Ignition Coil Housing Cracked (58/12)

This Technical Information replaces the TI dated July 7, 2014.

Information: **Procedure for replacing faulty ignition coils.**

Figure 2

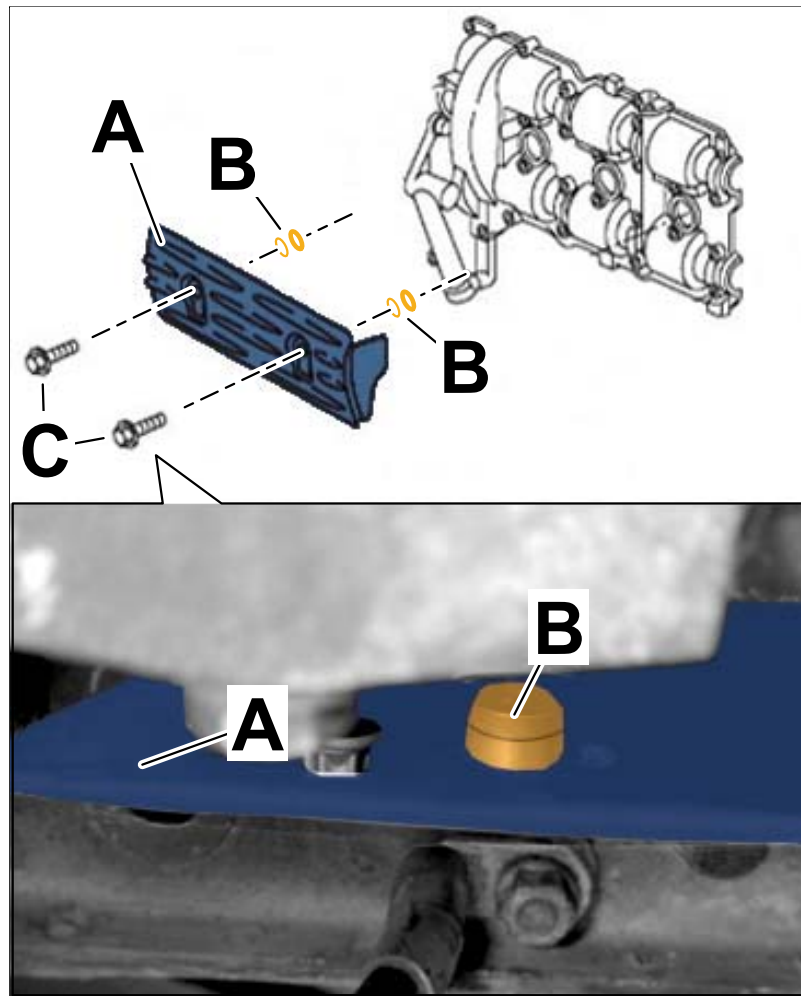
2 **When fitting the two heat shields** (already used; ⇒ *Figure 2-item A-*):

- two new, **longer screws** (Part No. 900.075.333.01, M6 x 25; ⇒ *Figure 2-item C-*) must be used.
- A **washer** (Part No. 999.025.220.30, **5 mm thick**; ⇒ *Figure 2-item B-*) must be used for each screw **and**
- **a washer** (Part No. 999.025.193.30, **3 mm thick**; ⇒ *Figure 2-item B-*) must also be used.

The two new washers (5 mm and 3 mm) must be fitted together between the heat shield and cylinder head ⇒ *Figure 2-item B-*) and will ensure a sufficient distance between the ignition coil and heat shield.
